SUBJECT: SALEM NUCLEAR GENERATING STATION, UNIT NO. 2 (TAC NO. M95384)

SALEM NUCLEAR GENERATING STATION, UNIT NO. 2

AMENDMENT TO FACILITY OPERATING LICENSE

Amendment No. 197
License No. DPR-75

FIGURE 2.1-1 REACTOR CORE SAFETY LIMIT - FOUR LOOPS IN OPERATION

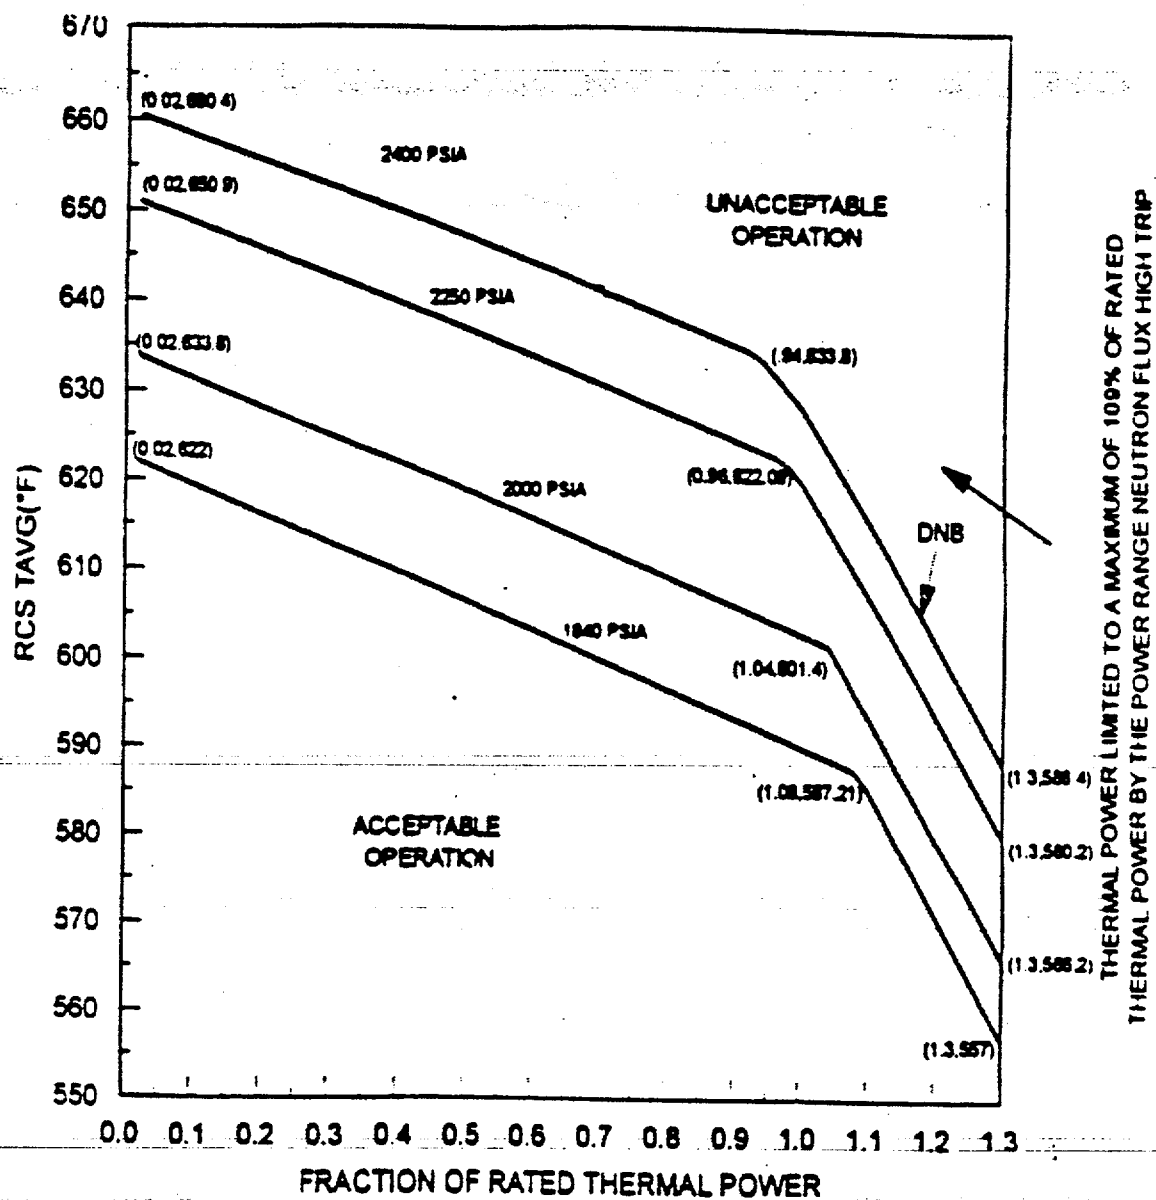
2.1.1 The combination of THERMAL POWER, pressurizer pressure, and the highest operating loop coolant temperature (T_{avg}) shall not exceed the limits shown in Figures 2.1-1 for 4 loop operation.

The curves of Figure 2.1-1 shows the loci of points of THERMAL POWER, Reactor Coolant System pressure and average temperature for which the minimum DNBR is no less than the design DNBR value, or the average enthalpy at the vessel exit is equal to the enthalpy of saturated liquid.

The discussion of 3-loop operation was deleted since it was not approved by the NRC. Accordingly, TS 2.1.1 was modified and references to future Figures 2.1-2 and 3.1-2 were removed.

**Figure B 3/4 2-1 TYPICAL INDICATED AXIAL FLUX DIFFERENCE
VERSUS THERMAL POWER**

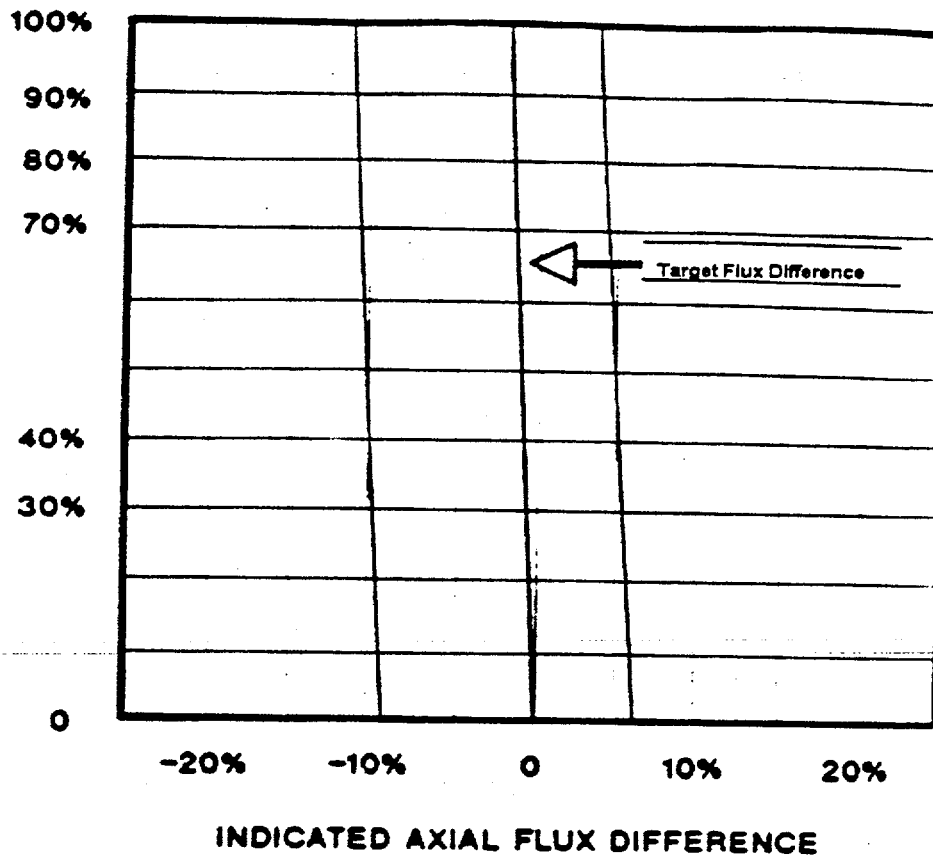
Figure B 3/4 2-1 shows a typical monthly target band.

* REFER TO COLR FIGURE 2 FOR ACTUAL LIMITS
